## **Jamaica Public Service Company Limited**

**SERVICES TO CARRY OUT HOT GAS PATH INSPECTION ON FRAME 6B UNIT  
HUNTS BAY POWER STATION**

## **QUESTIONS & ANSWERS**

See above screenshots during time of start- up

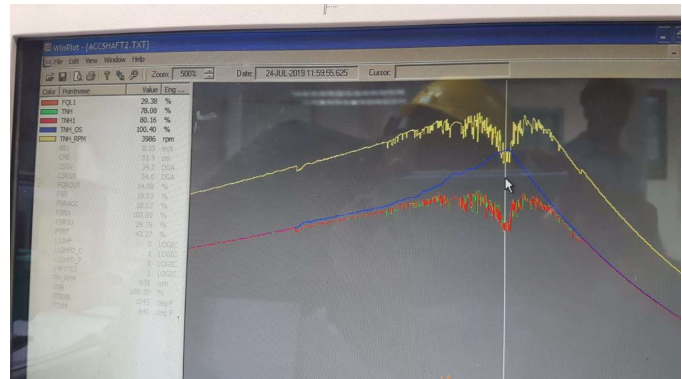
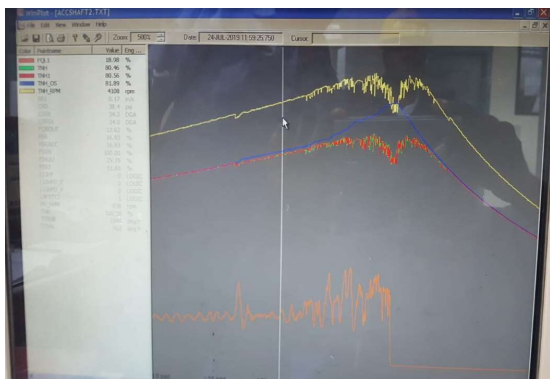
Give us the story on the failed installation of the accessory coupling.

This Frame 6B industrial gas turbine (GT-10) experienced a forced outage due to the accessory gear drive coupling on April 25, 2019. The coupling experienced a major failure on the contoured diaphragm section of the coupling flange at the turbine-end that resulted in the unit being rendered unavailable. Temporary repairs were conducted on the failed diaphragm by our local technical workshop. This repair involved the replacement of the failed flexible contour diaphragm section of the coupling with a stainless steel sheet metal of similar thickness. The unit was then returned to service but rendered impaired until the coupling is replaced with one that meets OEM specification.

In July 2020, an outage was conducted to install a newly procure coupling with the supervision of a third-party Technical Adviser (TA). Upon completion of the coupling installation, several attempts were made to recommission the unit. During each start-up, the unit constantly tripped on 'Control Speed Signal Trouble - HP'. This led to inspection and recalibration of the speed pickups and a comparison between the coupling removed with the new coupling (see drawings).

However, despite the checks conducted, we had constant trips on Control Speed Signal Trouble- HP once the unit ramps up to 4000+ rpm. The old coupling was then reinstalled and the unit returned to service. Additional assessment was conducted on the new coupling, the results of this assessment identified magnetism of the coupling resulted in misreading in the speed pick-ups and the inability of the unit to synchronize.
